MAPLE AVENUE CONNECTIVITY PROJECT

MANDATORY REFERRAL MR2025001

The City of Takoma Park submitted a Mandatory Referral for separated bike lanes to be constructed on both sides of Maple Avenue between the DC line and Hilltop Road/Sligo Creek Parkway in Takoma Park, Maryland.

SECTION 1 – COMMENTS

Figure 15: Typical Chicane Plan View

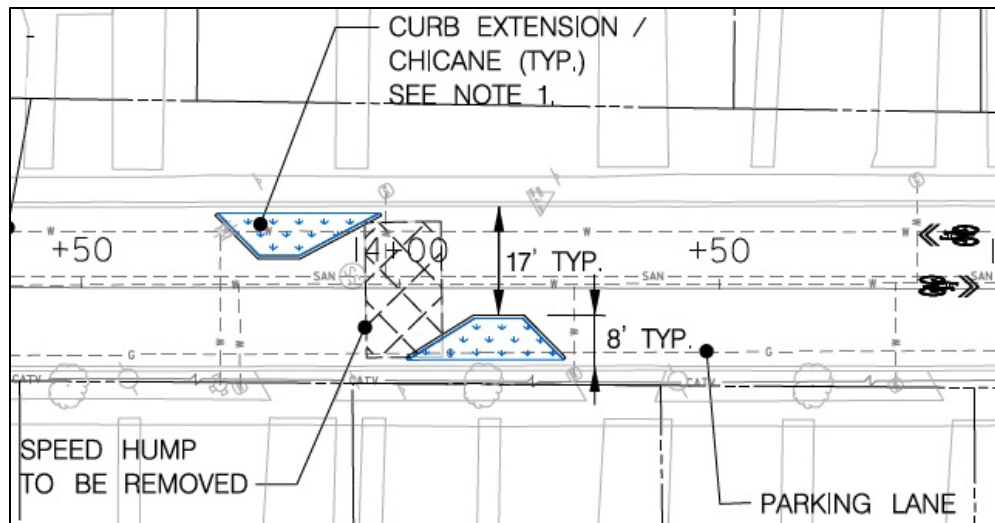
Given the generally steep downgrade of Maple Avenue between the DC Line and Philadelphia Avenue, the grade should be considered in both siting the chicane locations and designing the chicane spacing. Chicanes are likely to reduce the number of on-street parking available by about two to three spaces at each location. Chicanes that intersect with Ride On bus stops should provide proper clearance for bus stops.

Comment: Design the chicanes to comply with bus turning radii requirements from the bus operator (Ride On Transit).

While the chicane bulb outs are effective at traffic calming, maneuvering buses and larger trucks (SU-40) could create a visibility conflict for bicyclists and shared traffic.

Comment: Conduct auto-turn analysis to assess potential pinch point conflicts of proposed chicanes for trucks, buses, and passenger vehicles. Coordinate closely with MCDOT and assess the appropriate spacing of curb extensions relative to potential conflict zones.

Figure 27: Accessible On-Street Parking PROWAG Requirements

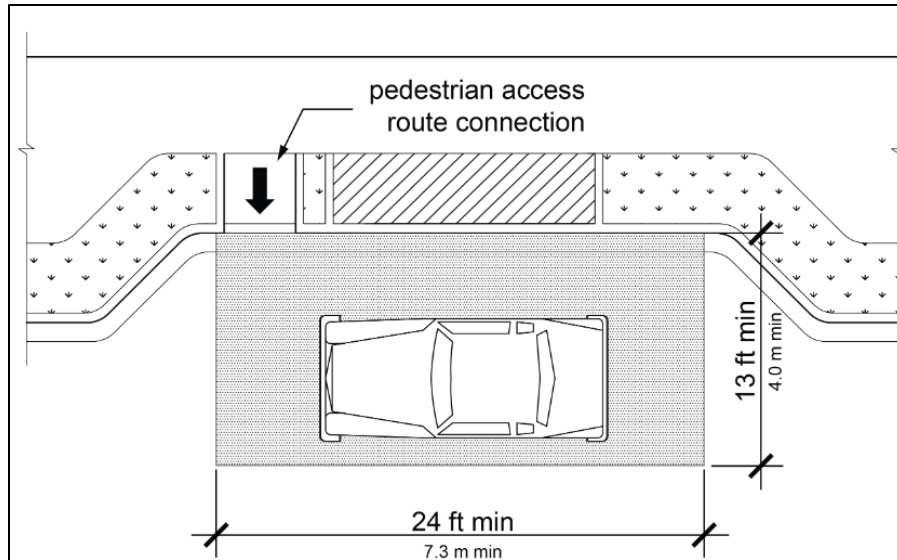
When in full effect, PROWAG will mandate the provision and design of accessible parking spaces. A standard on-street accessible parking space design is illustrated below in Figure 27 and requires a wider parking bay (13 feet minimum).

Comment: Accessible parking should be designed along the corridor at logical and regular locations. For the proposed project, a total of three accessible parking spaces are needed to comply with the Montgomery County accessible parking requirements.

Staff conducted an estimate of the number of planned on-street parking spaces on Maple Avenue between Philadelphia Avenue and Hilltop Road/Sligo Creek Parkway at 65 parking spaces (plans do not currently show individual parking spaces marked). Based on PROWAG requirements, this would require a total of three accessible spaces to be located at regular intervals along this section of the corridor.

Figure 29: Bus Boarding Island - Midblock

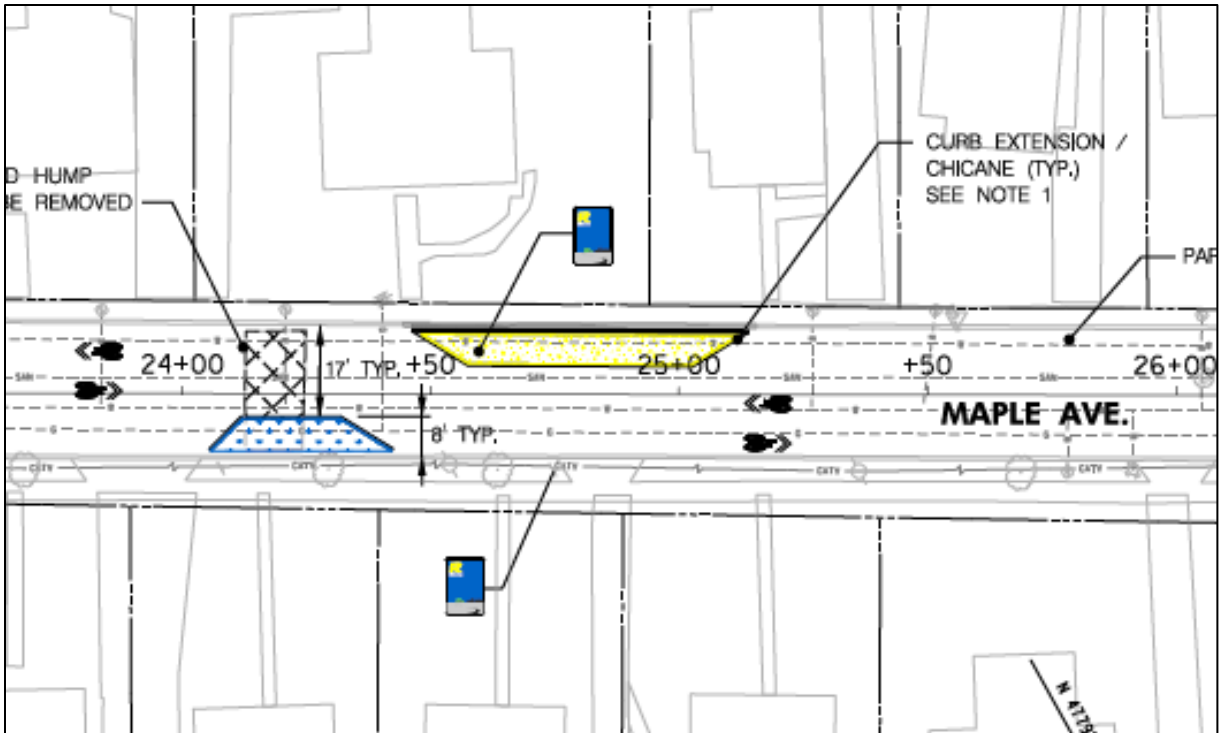
A photo of a typical bus boarding island from San Francisco is shown below in Figure 28. The Project shows proposed bus boarding islands at Tulip Avenue, midway between Tulip Avenue and Valley View Avenue, Grant Avenue, Sherman Avenue, and the Sligo Creek Parkway. The midblock example is shown below in Figure 29, an example with a bus boarding island located on the intersection approach is shown below in Figure 30, and an example with a bus boarding island on the intersection departure is shown below in Figure 31. The Montgomery County Accessible Design Guide requires that bus boarding islands be 10-feet wide minimum. However, the width of the bus boarding islands proposed by this project is 8 feet.

Comment: Widen the bus boarding islands to 10 feet to meet Montgomery County Accessible Design Guide requirements.

Figure 36: Intersection of Maple Avenue with Philadelphia Avenue (MD 410) Design Compliance

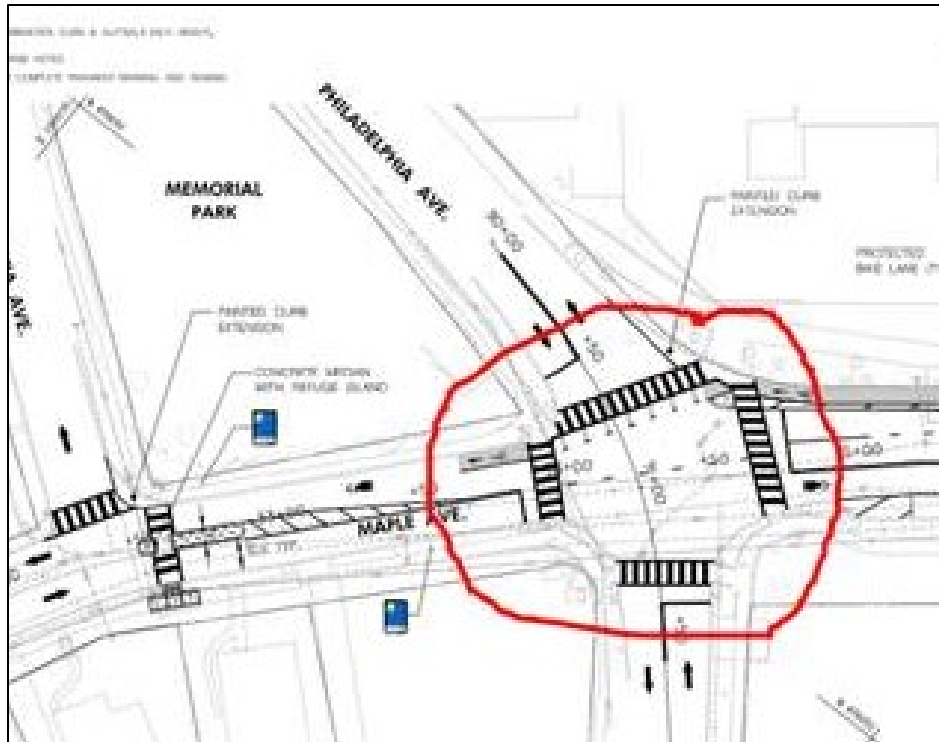
The curb radius of the northwest corner of the Maple Avenue intersection with Philadelphia Avenue is excessively wide (see Figure 36). This turn should be able to accommodate a bus design vehicle at the very least, however, it is more generous than needed and should be re-evaluated.

Comment: Conduct an auto turn analysis at the intersection of Maple Avenue with Philadelphia Avenue to determine if the turn radius can be tightened.

Figure 40: Proposed Improvements on Parkland at Sligo Creek SVU1

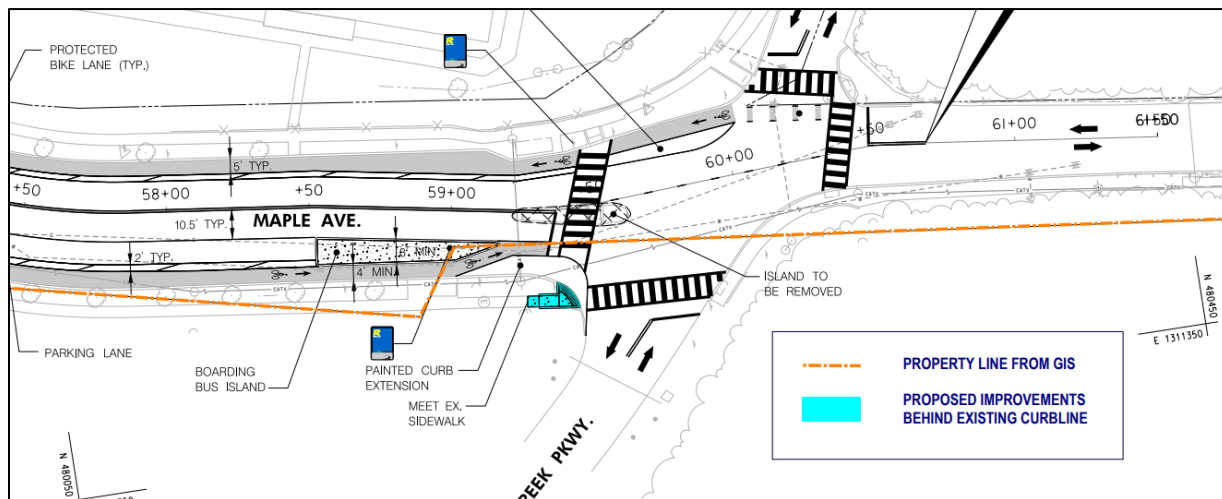
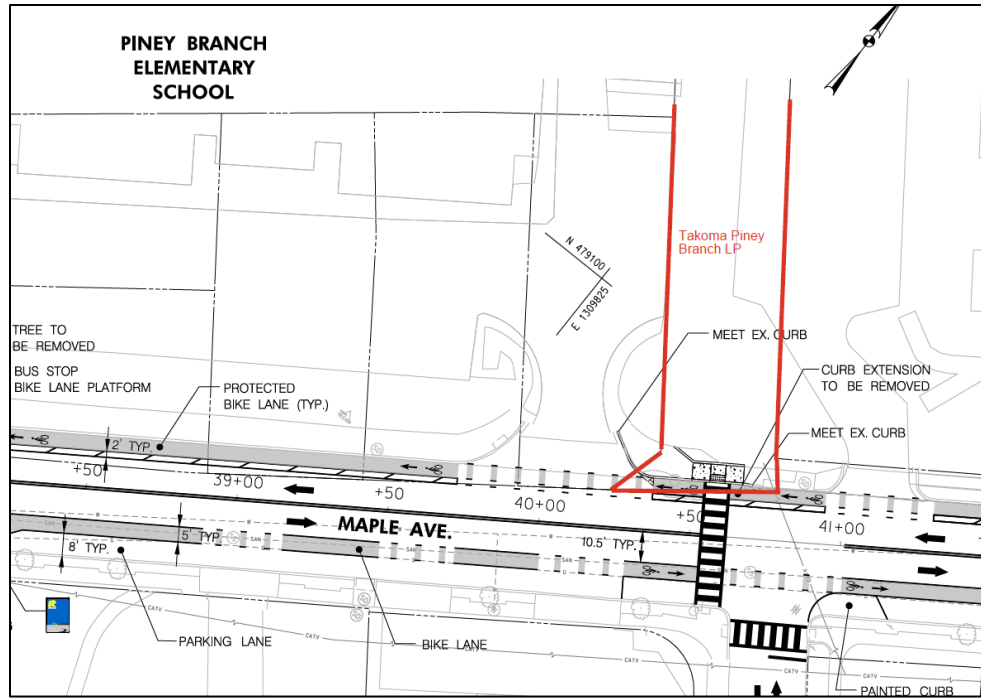
Comment: Construction plans must be submitted to the Maryland National Capital Park and Planning Commission (M-NCPPC) Department of Parks for review as part of the Park Construction Permit process to ensure that all work is performed in accordance with M-NCPPC standard details, specifications, and policies. No work on parkland may occur until an approved Park Construction Permit is issued for the project.

Comment: Montgomery Parks tree mitigation will be fulfilled through either (1) replacement planting on parkland at a rate of one-inch to one-inch diameter or (2) a monetary per inch caliper basis at the rate of \$200/diameter inch, to be paid to Montgomery Parks before completion of construction. The construction plans must locate all trees (with size and species) that are 6" DBH and greater within 25 feet of the proposed Limit of Disturbance on park property.
